**COUNTY OF SAN MATEO
PLANNING AND BUILDING DEPARTMENT**

SUBJECT: EXECUTIVE SUMMARY: Consideration of a Design Review Permit, a Coastal Development Permit, and a Certificate of Compliance (Type B) to legalize a 6,079 sq. ft. parcel and to allow construction of a new 2,909 sq. ft. single-family residence, including a 728 sq. ft. two-car garage and shop area, on the subject property, and an approximate 33-ft. public roadway extension of Sevilla Avenue (30-ft. wide) to serve the project. The project is located on Sevilla Avenue between Madrona Avenue and Sonora Avenue in the unincorporated El Granada area of San Mateo County. The project is appealable to the California Coastal Commission.

County File Number: PLN 2016-00153 (Menendez)

SUBJECT: Consideration of a Design Review Permit and a Coastal Development Permit, pursuant to Sections 6565.3 and 6328.4 of the County Zoning Regulations, as well as a Certificate of Compliance (Type B) to legalize a 6,079 sq. ft. parcel, pursuant to Section 7134.2 of the County Subdivision Regulations, to allow construction of a new 2,909 sq. ft. single-family residence, including a 728 sq. ft. two-car garage and shop area, on the subject property, a

**SITE DEVELOPMENT AND
 AREA DISTRIBUTION AND
 LANDSCAPE PLAN**

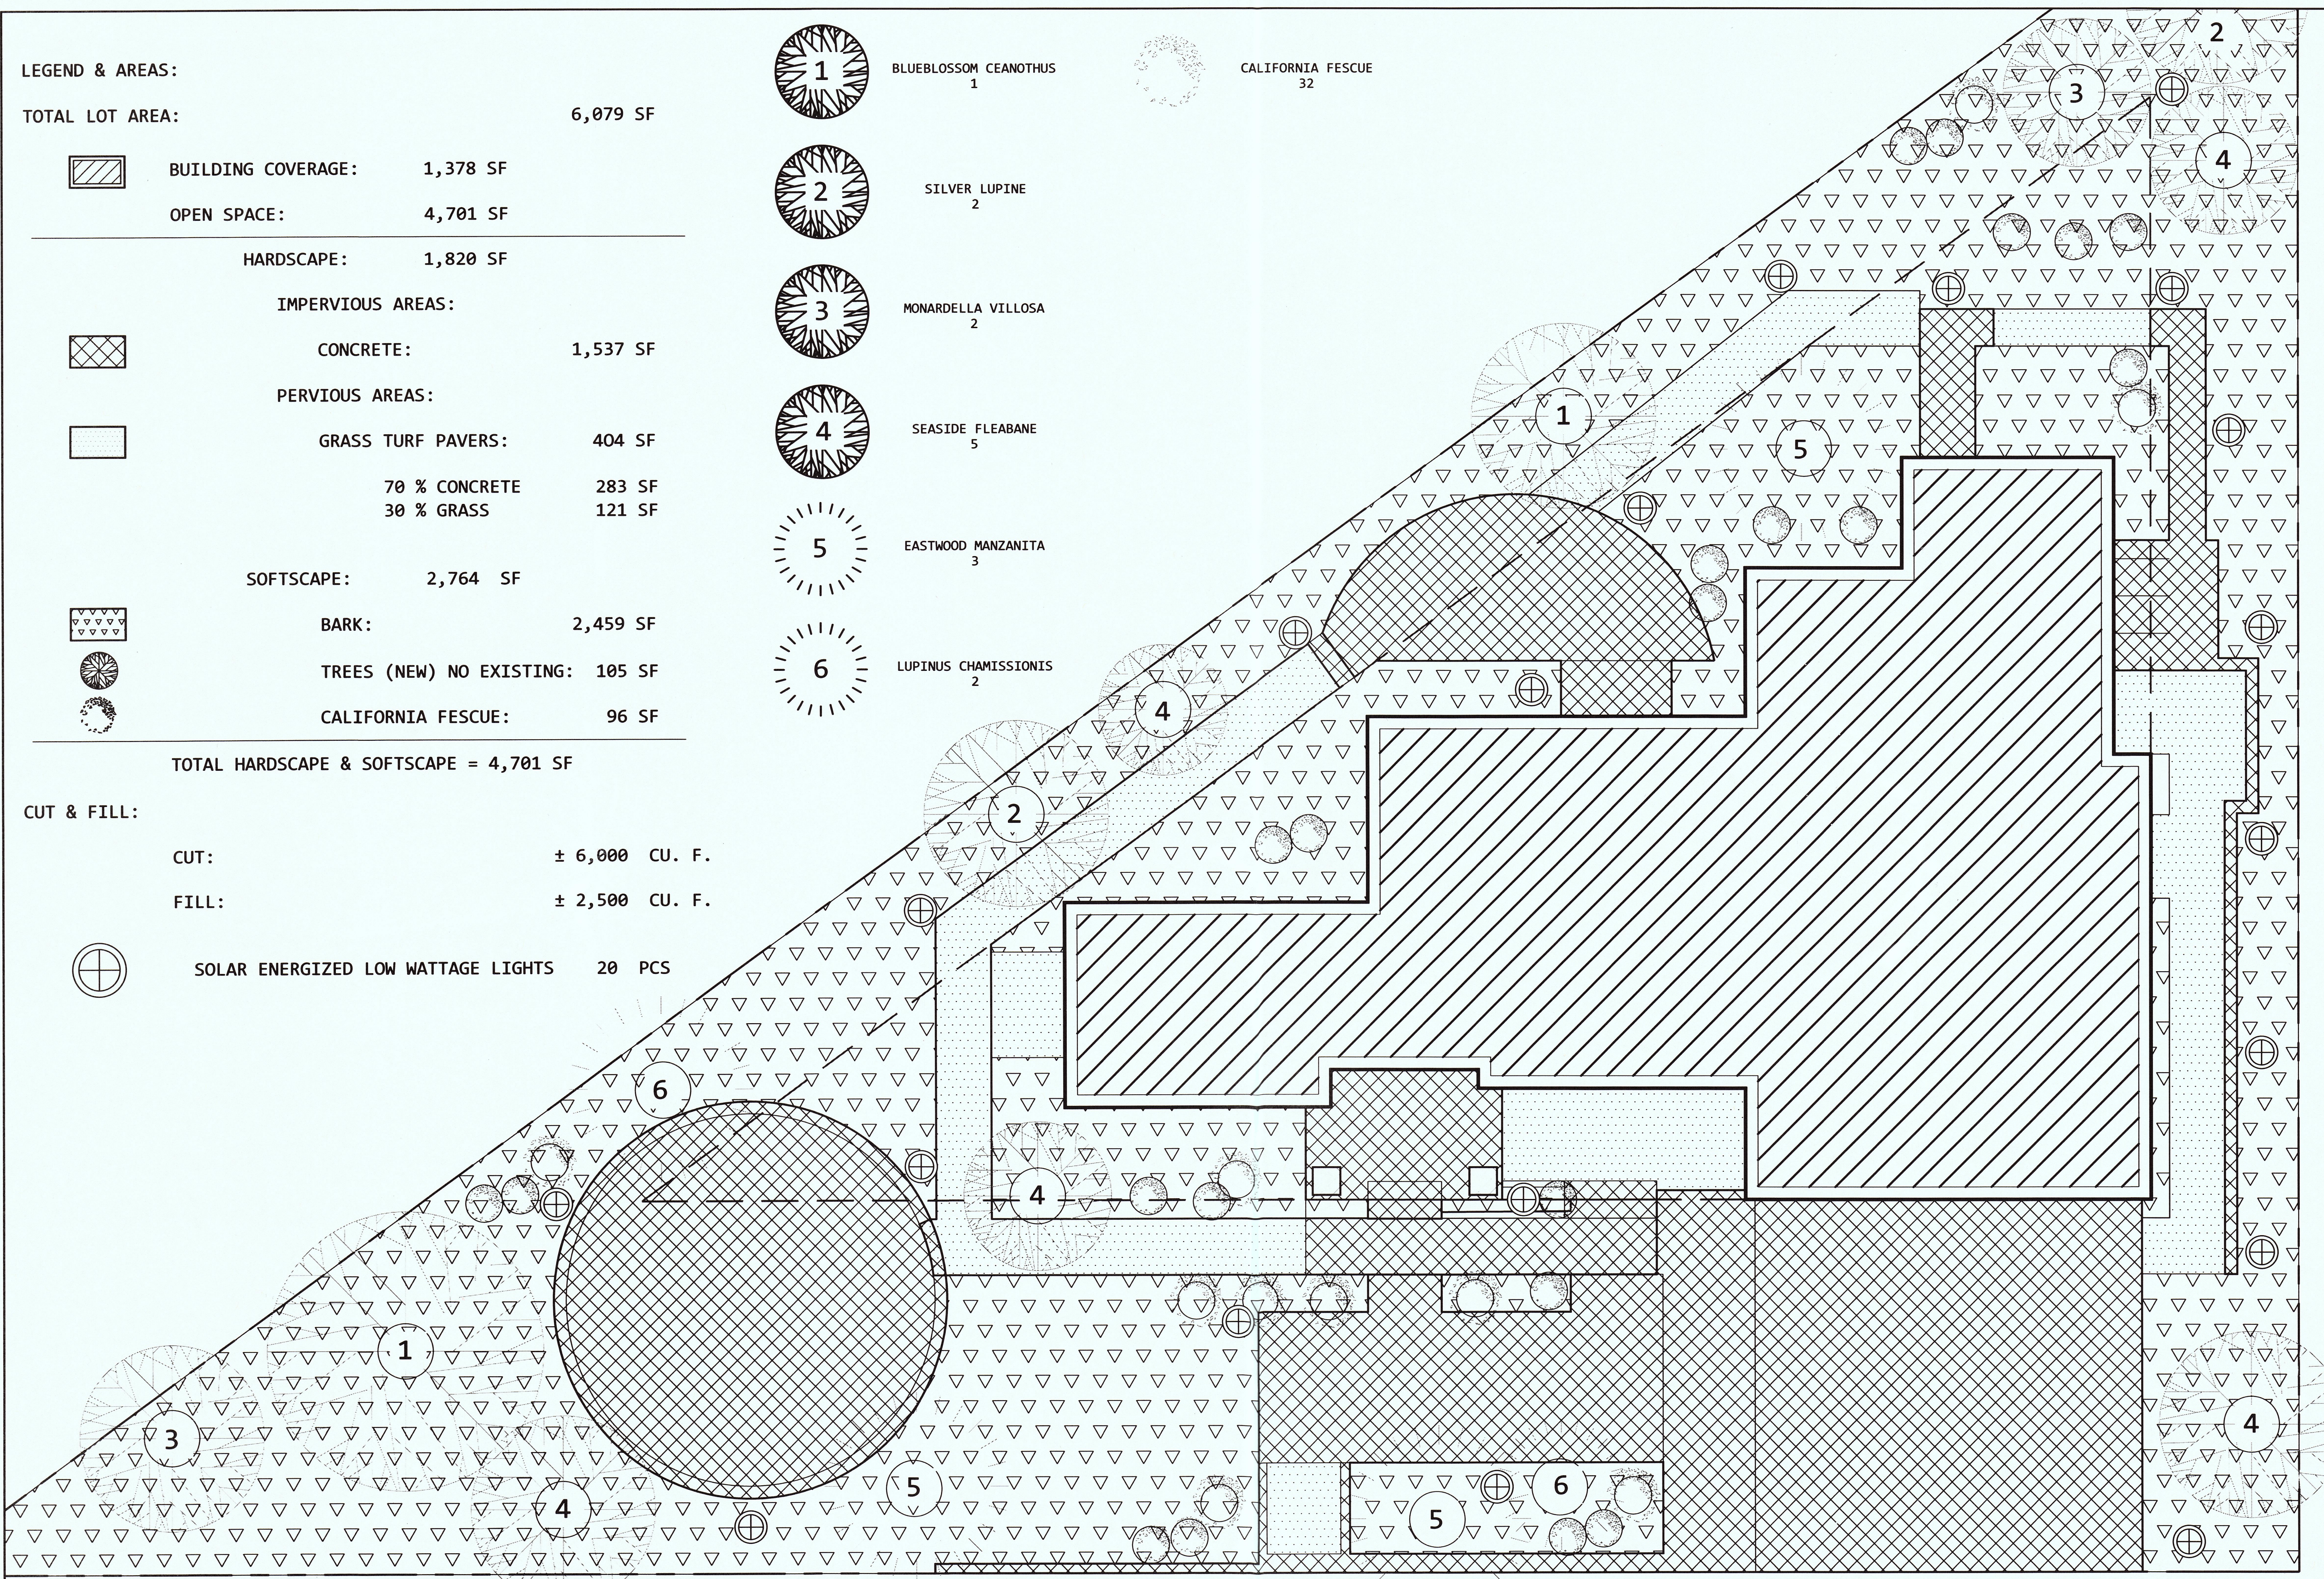
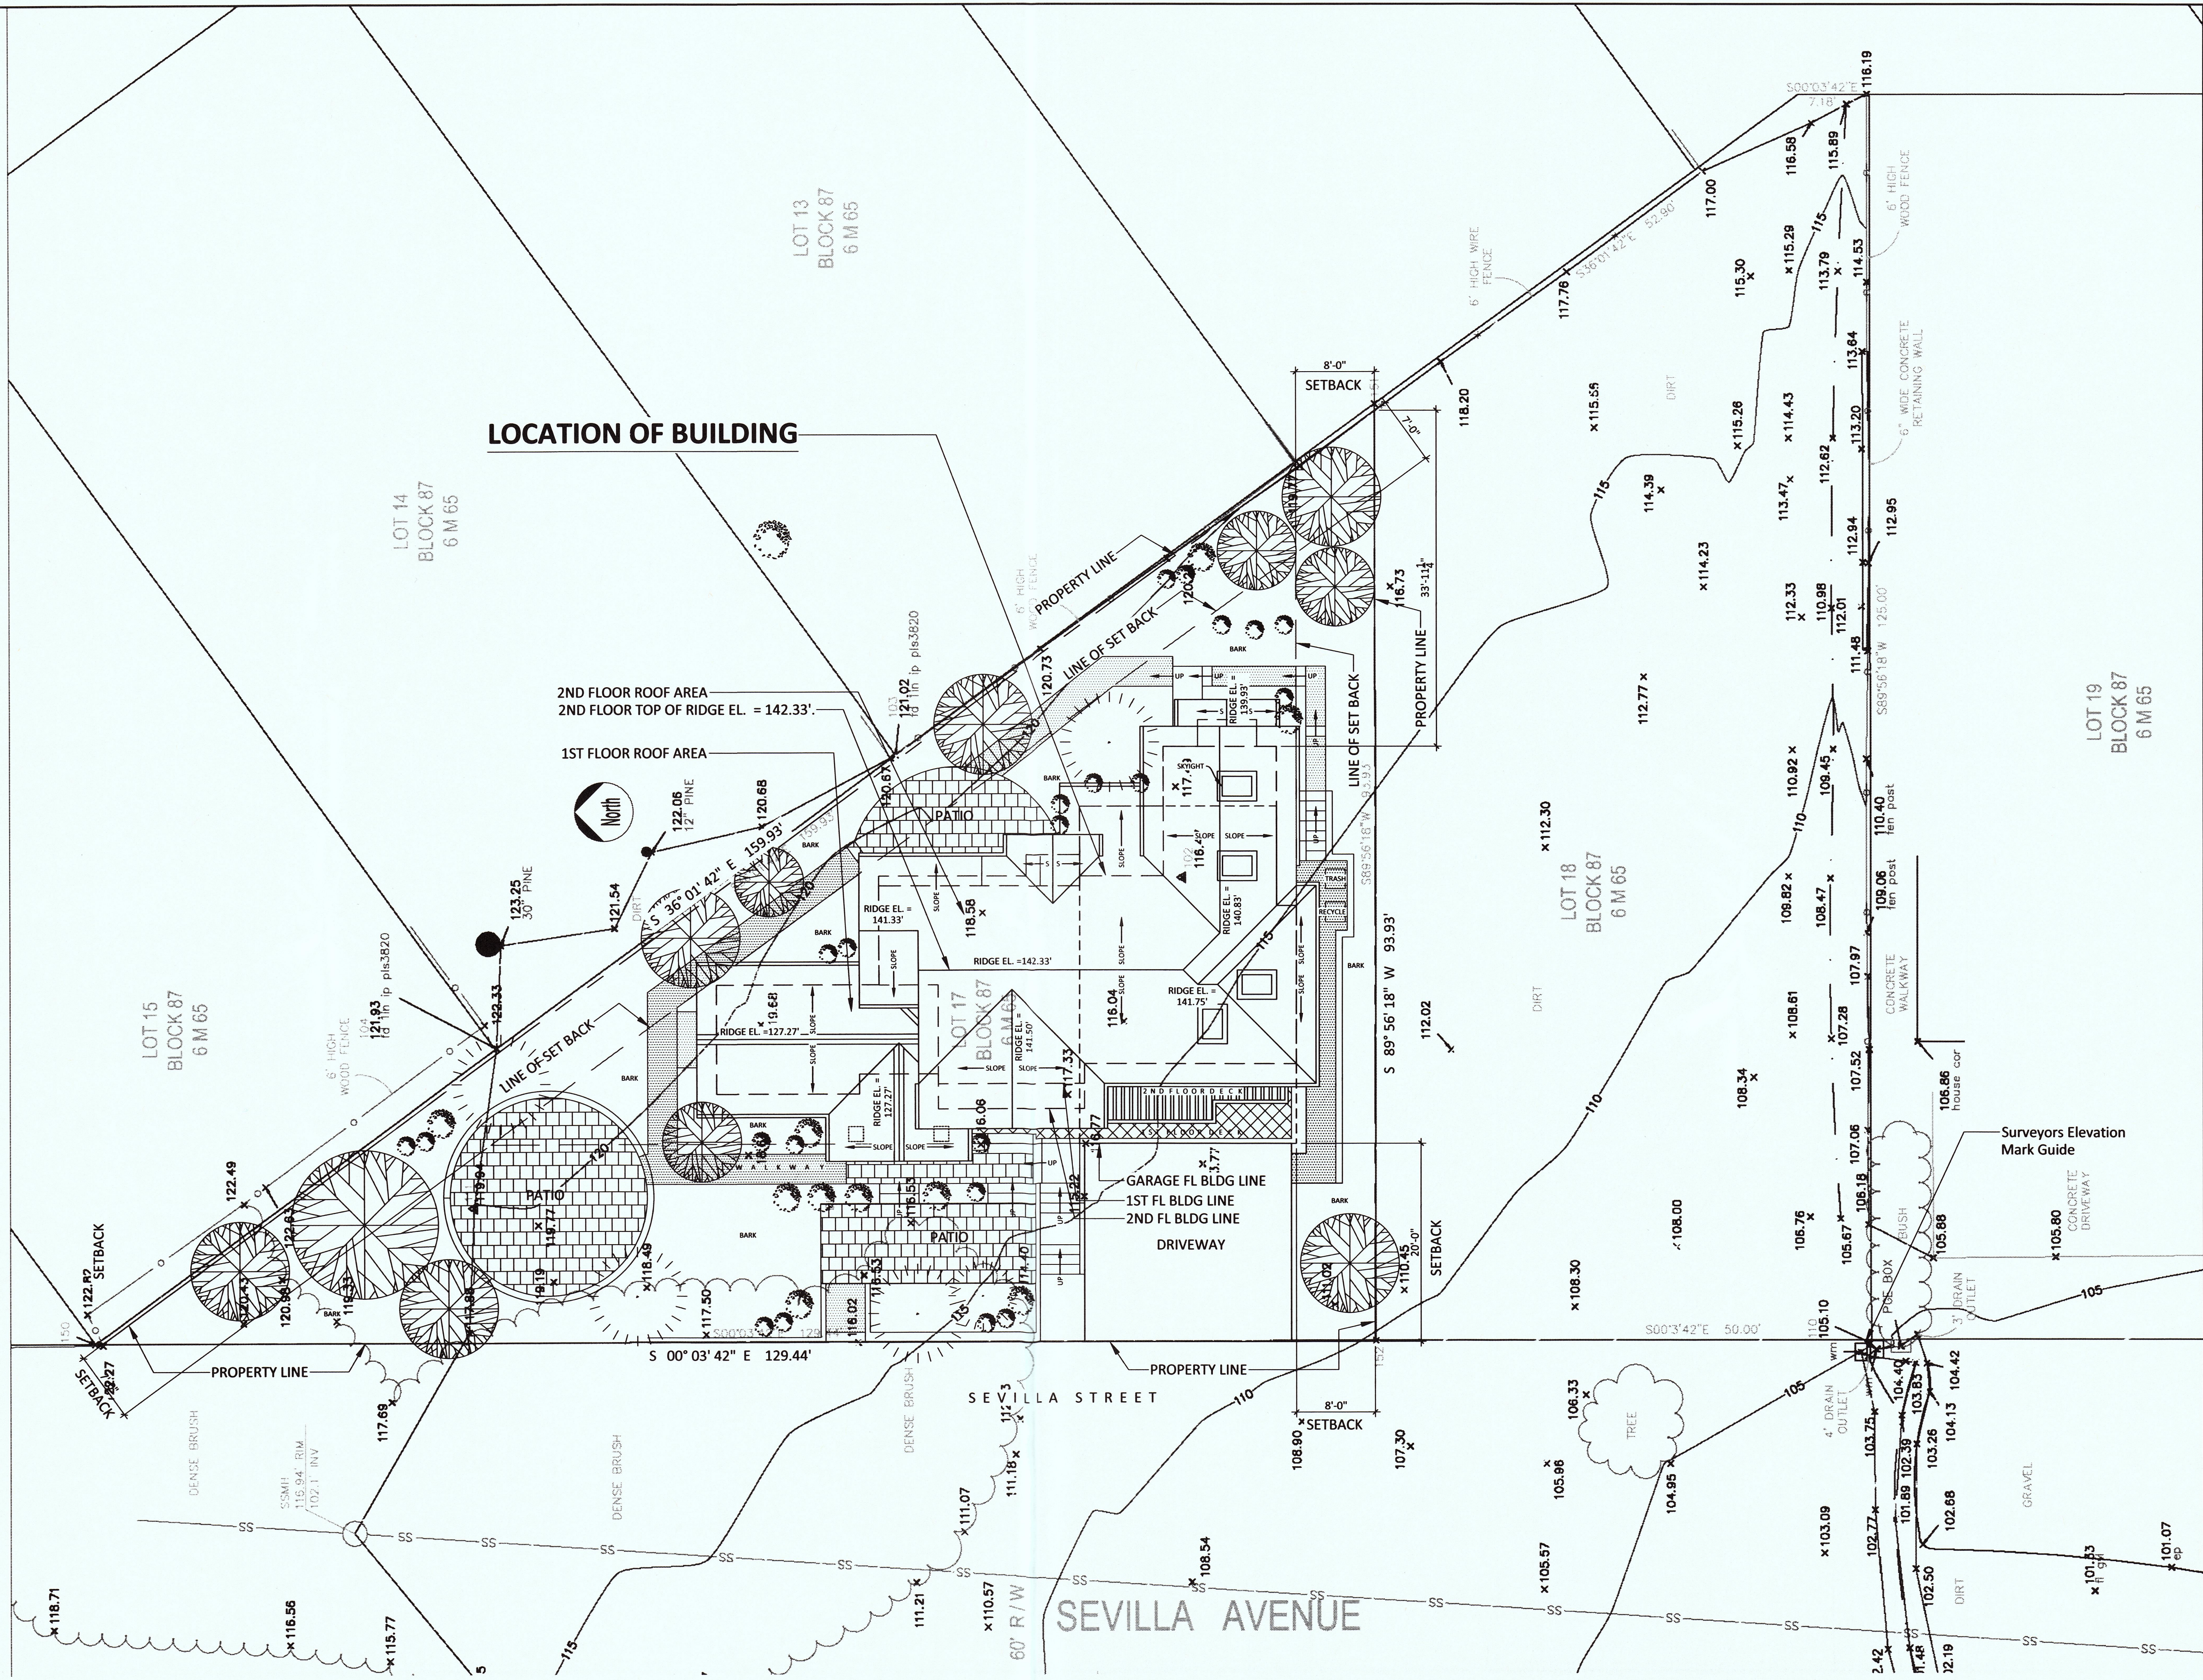
- a. Replace bark with wild grass seed in landscape areas.
- b. Use permeable pavers in lieu of stamped concrete for all patios (at a minimum).
- c. Use a maximum of one exterior light per door except for the garage where two lights are acceptable per the proposed design.
- d. Add a belly band to the right-side elevation at the same height as the second level deck.
